B. [PLANNED UNIT DEVELOPMENT 1, 2024, INCLUDING SITE PLAN 54-7-2024](#)

PROPOSAL: Construction of gasoline service station with drive-through restaurant within RC-2, Multiple-Family Residential District

Case: PUD 1, 2024, including site plan 54-7-2024
Site: 27815 and 28025 Middlebelt Road
(Parcels 23-11-477-109, 23-11-477-013, and 23-11-477-014)
Applicant: SkilkenGold Real Estate Development
Application Date: May 15, 2024 (Final PUD Plans- July 16, 2024)
Zoning: RC-2 Multiple Family Residential District

DATE: August 5, 2024
TO: Planning Commission
FROM: James Cubera, City Engineer 
SUBJECT: PUD 2-2024
Sheetz
PJ #11-24-90
27815 & 28025 Middlebelt
22-23-11-477-109 &013

<small>3000 S. WALKER AVENUE, SUITE 200 SOUTHFIELD, MI 48075 WWW.KIMLEY-HORN.COM</small>	 <i>Tyler Smith</i>
	SITE PLAN
SHEETZ - 12 MILE AND MIDDLEBELT	
ORIGINAL ISSUE: 07/16/2024 KHA PROJECT NO. 268593001 SHEET NUMBER C1.0	REVISIONS NO. DATE BY

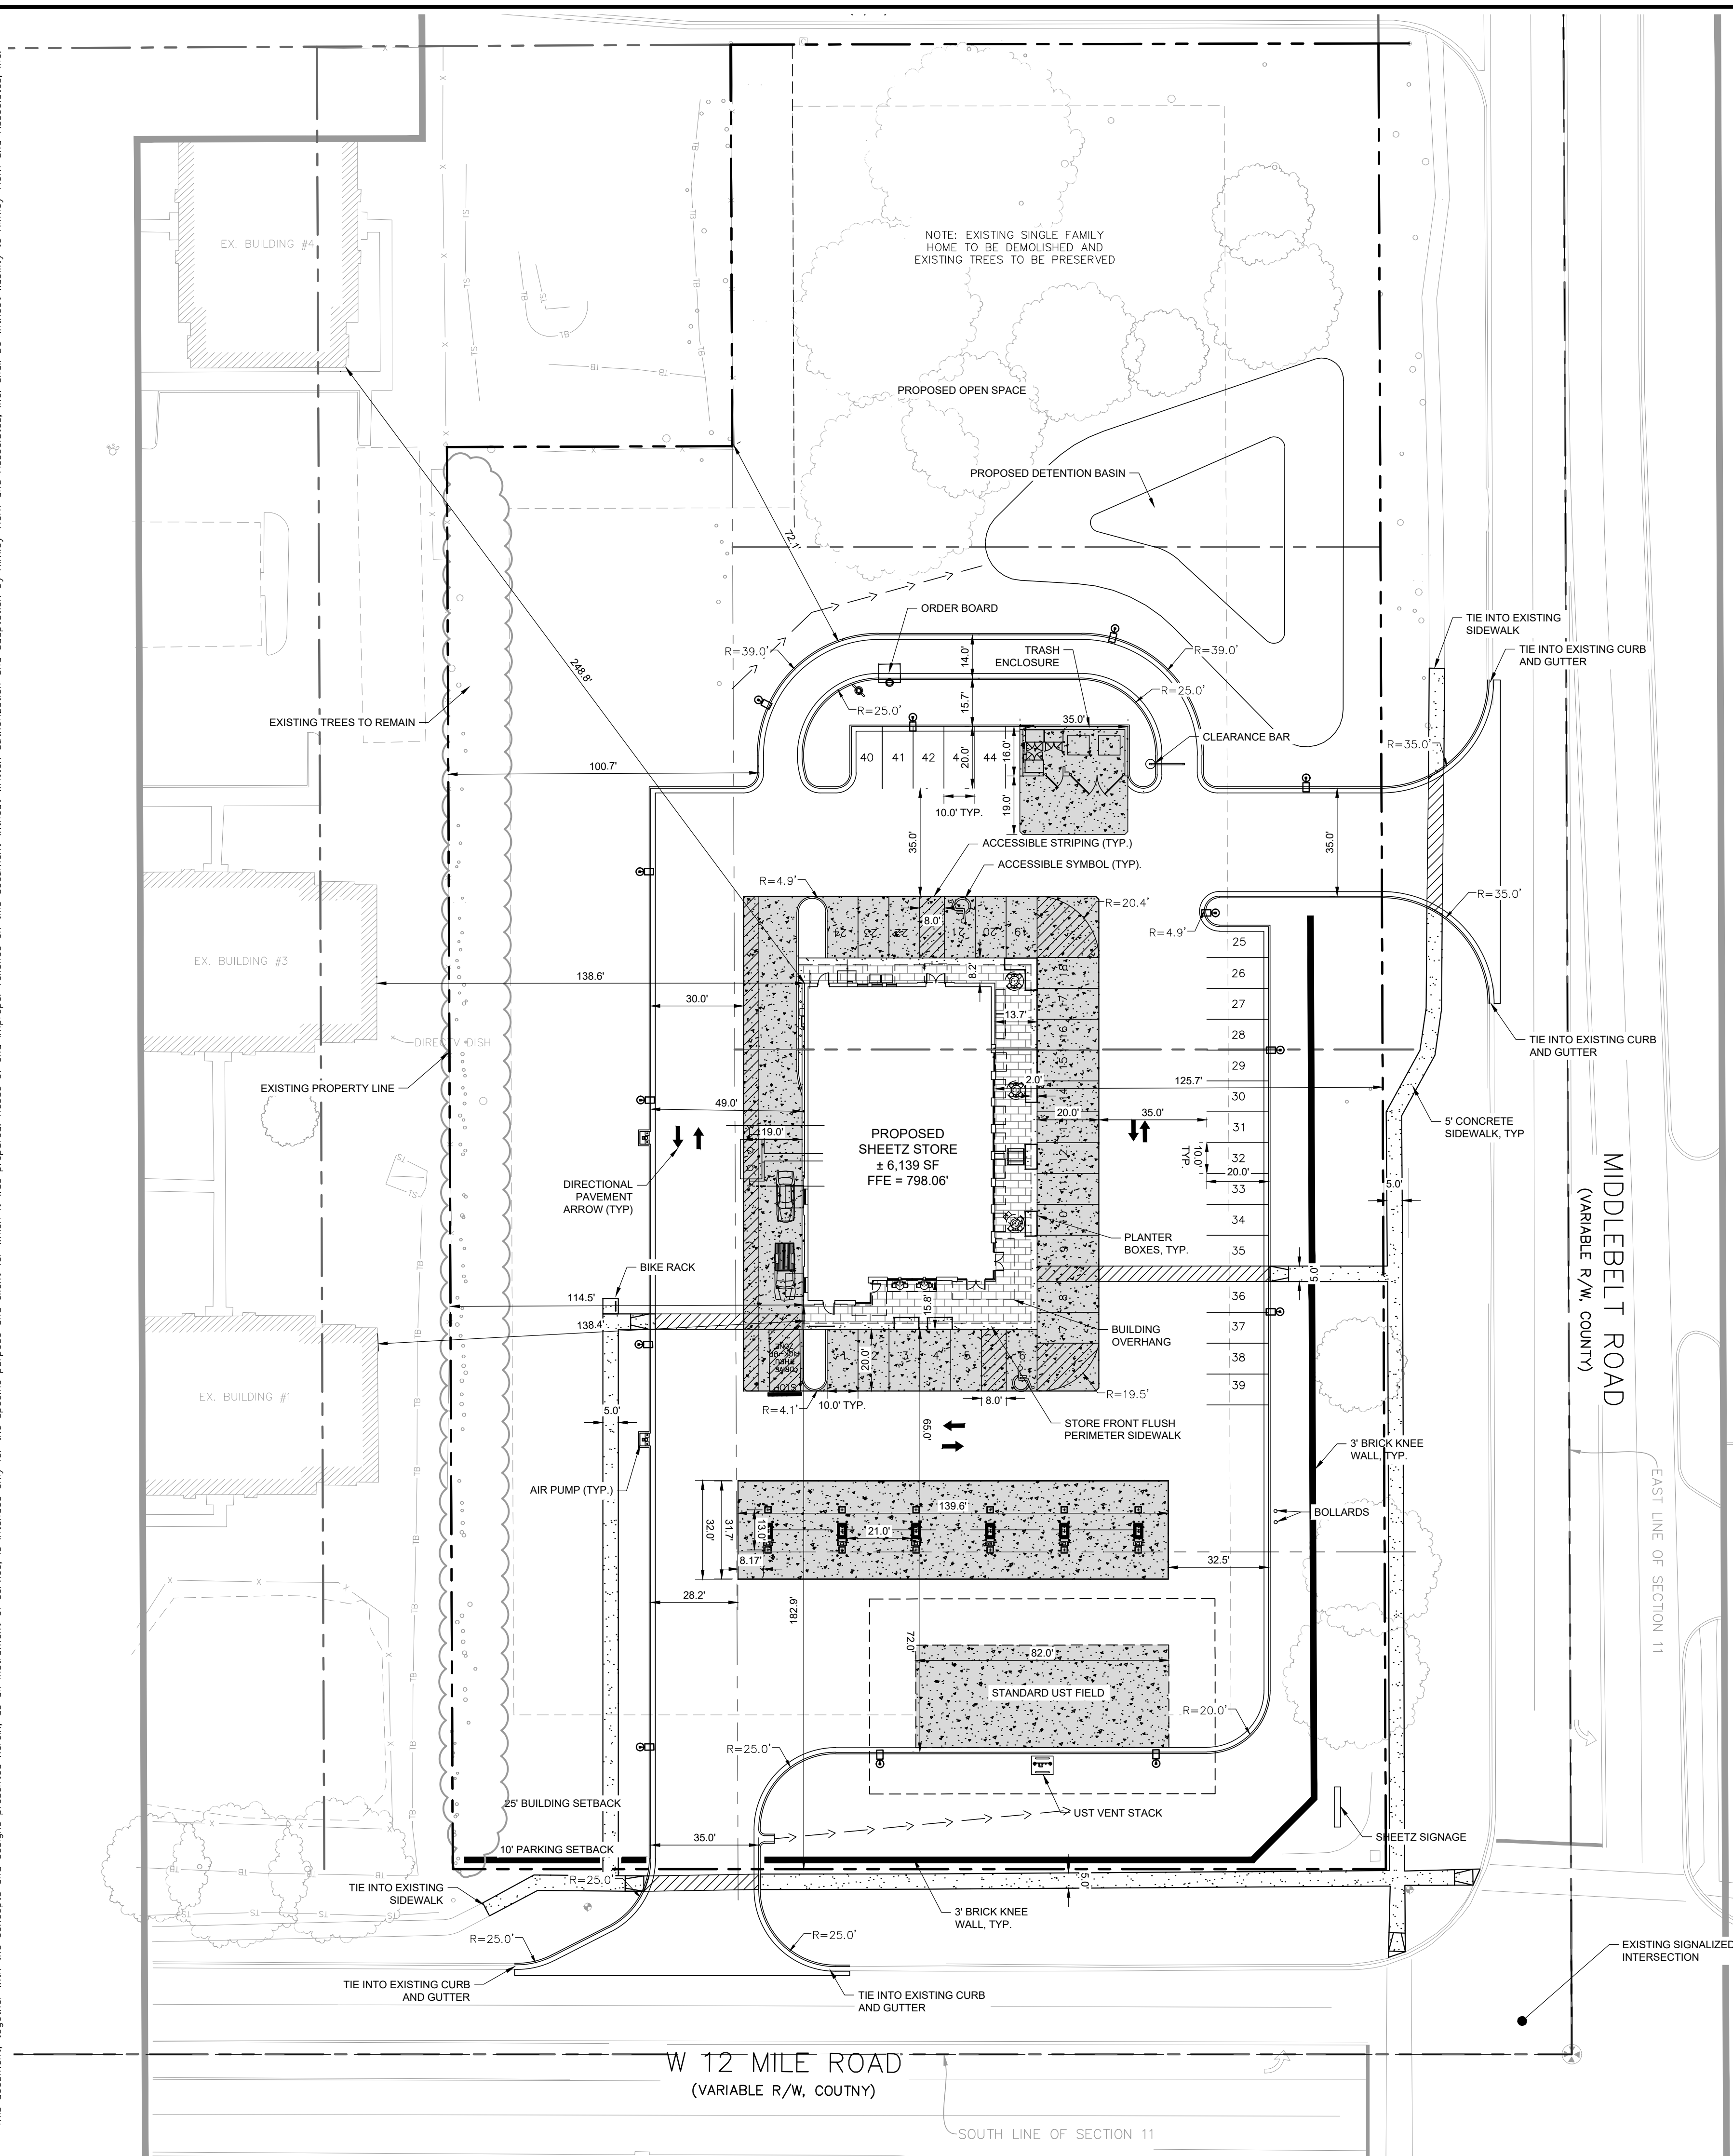
¹ The parking schedule on Sheet C1.0 lists 42 spaces, but the plans show 44.

- b. **Drive-Throughs (34-5.2.12).** The applicant has proposed a drive-through use as a part of this development. The drive-through meets all of the minimum standards of 34-5.2.12 except for the following:
- i. **Drive-through lanes shall provide one (1) by-pass lane to allow unobstructed travel for vehicles to pass those waiting to be served. This standard is not met, and relief from the ordinance is needed.**

- ii. The stacking arrangement is not indicated on the plans. It should be confirmed that sufficient room is provided to accommodate five stacking spaces between the menu board and the end of the drive-thru lane.

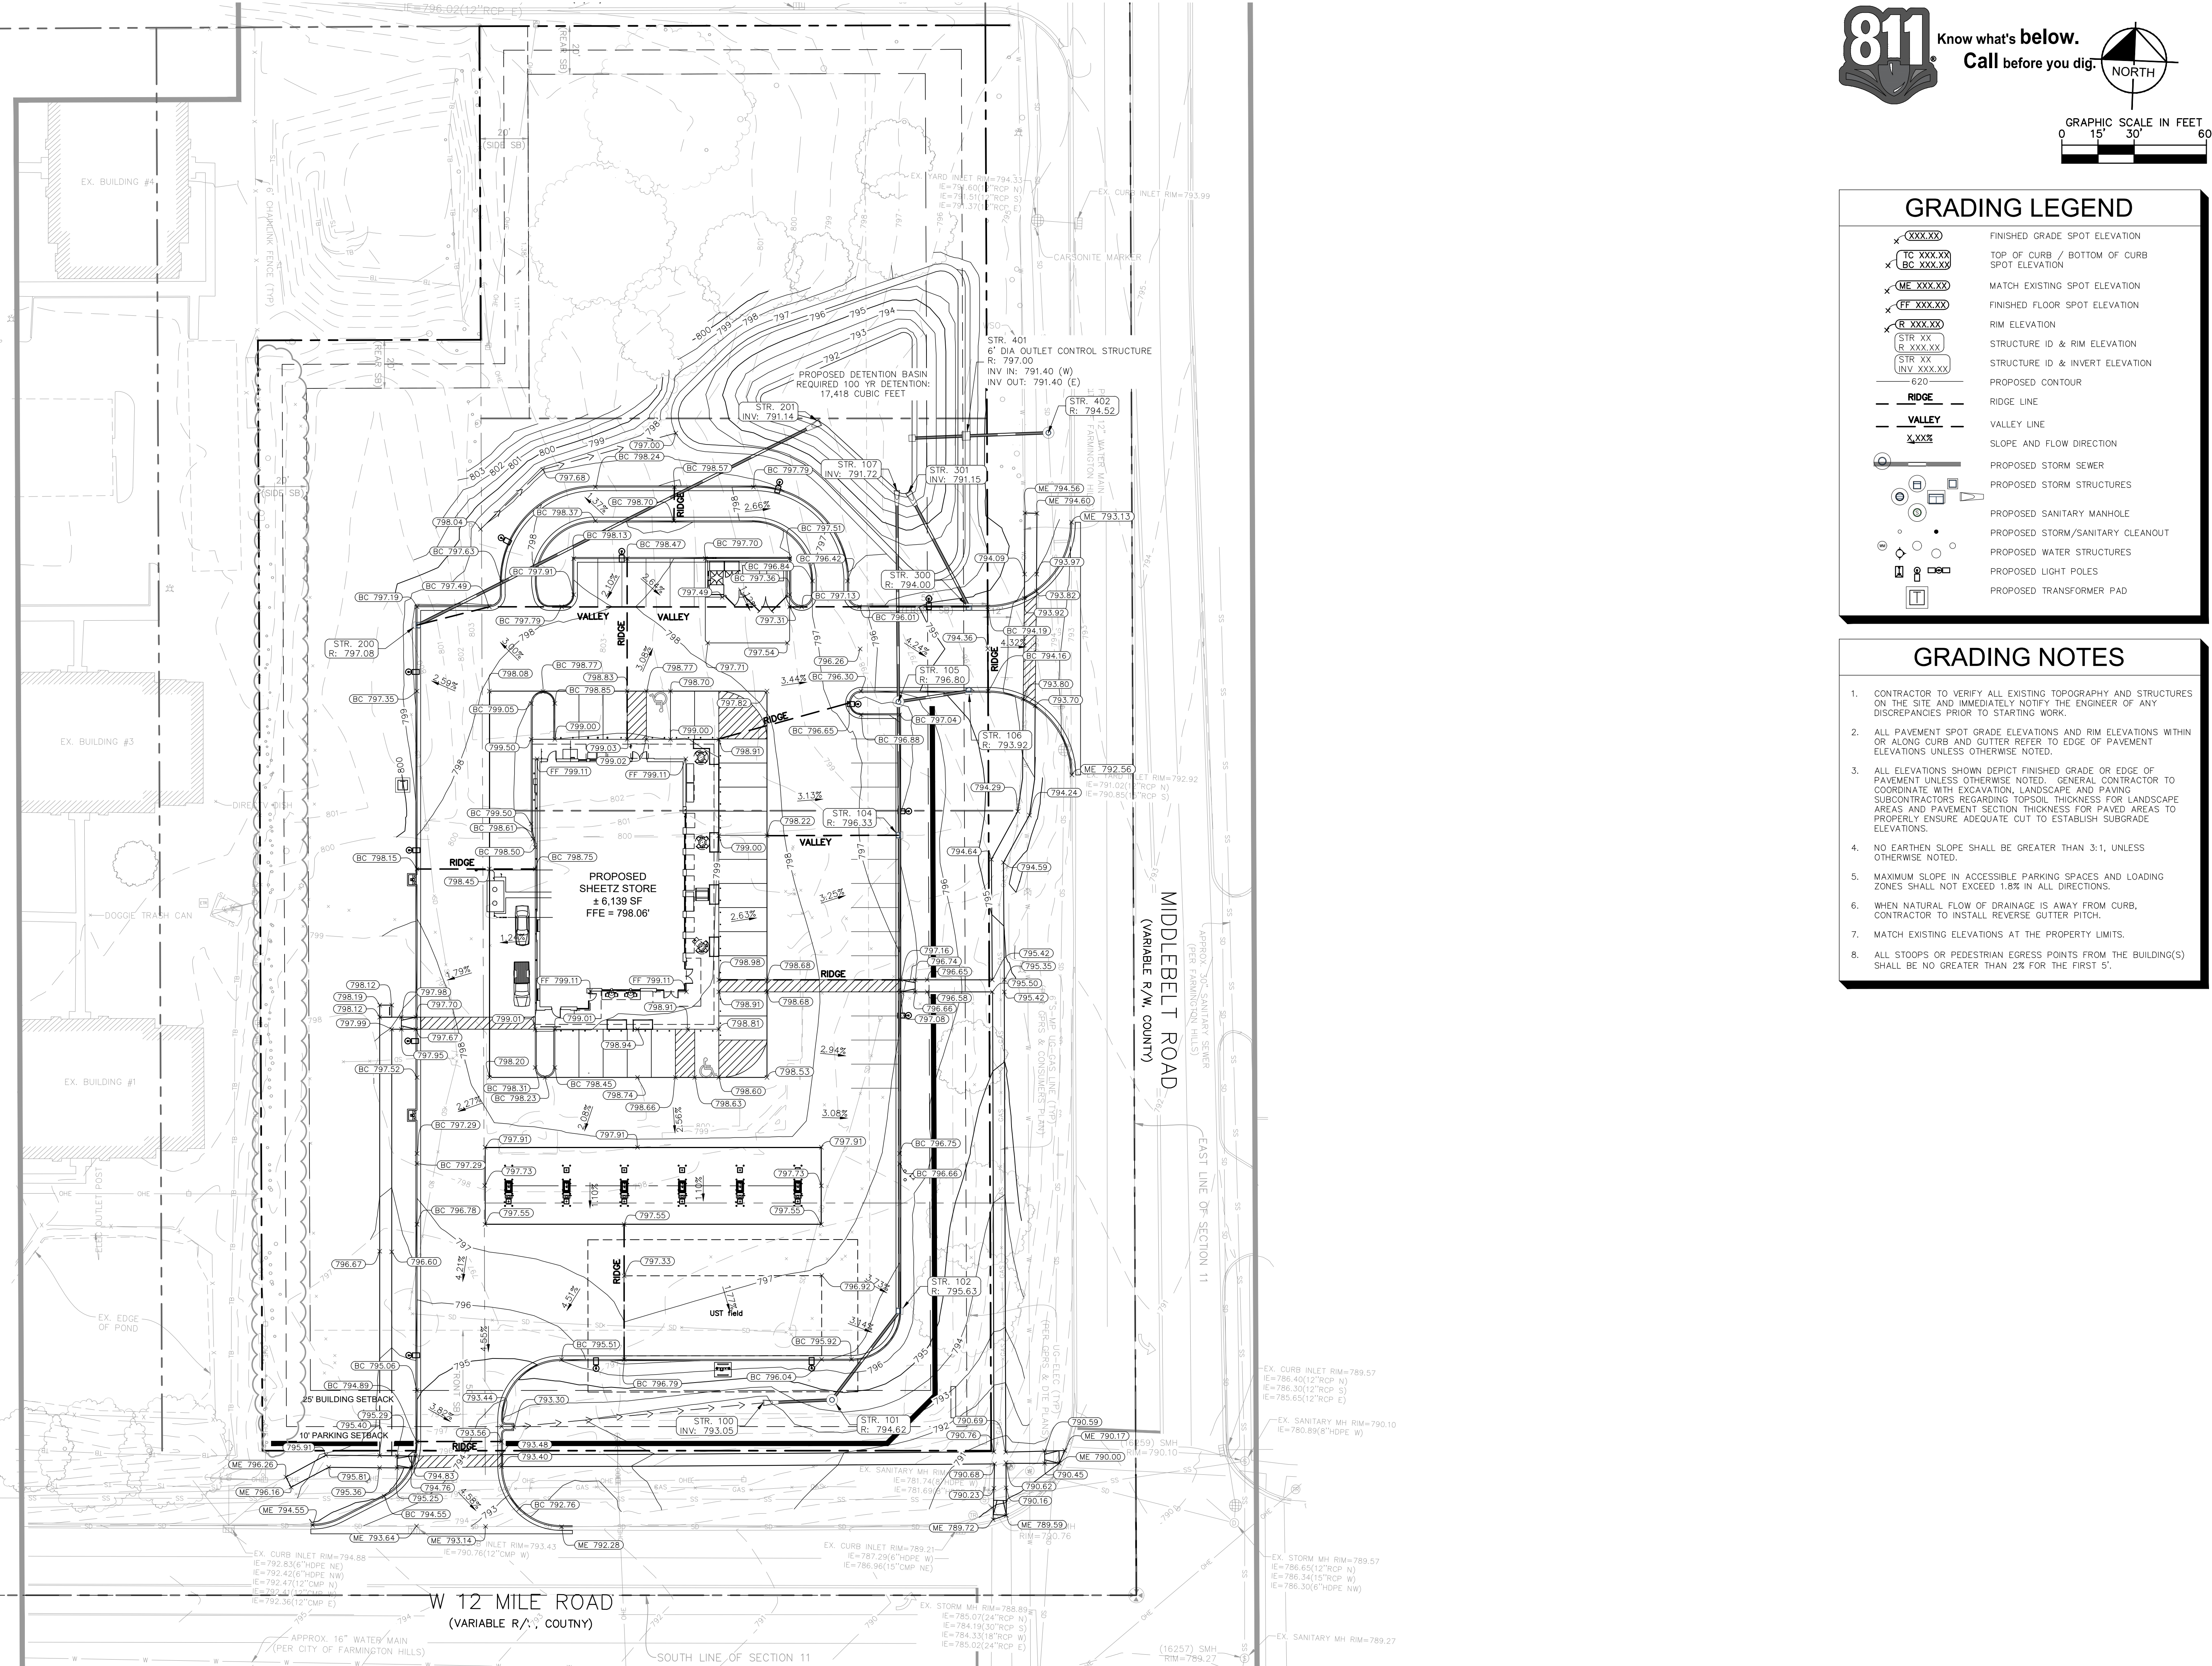
We note that an updated preliminary grading plan indicating a detention pond was received on July 25, 2024. It will be reviewed in detail once the plans are formally submitted for construction review. Of particular concern is the need for a downstream analysis of the offsite outfall storm sewer to verify if it has the proper depth and capacity.

6. Regarding the onsite parking lot, additional storm sewer appears necessary to properly drain it. This can be discussed during site review. Additionally, we question what will be provided in the area onsite north of the detention pond.
7. Attached are comments from our Environmental Engineer Tyler Sonaga. The proponent needs to address these items. Any questions regarding these comments should be referred to Tyler at 248-871-2533.
8. The plans identify a 50 foot right of way on Middlebelt Road and on 12 Mile Road. Please note that the ultimate right of way on these two major roads is 120 feet with 60 feet extending from the centerline in each direction. If these rights of ways have not been dedicated at this time, it is suggested that the proponent dedicate an additional 10 feet in order to conform with the City's master right of way plan.
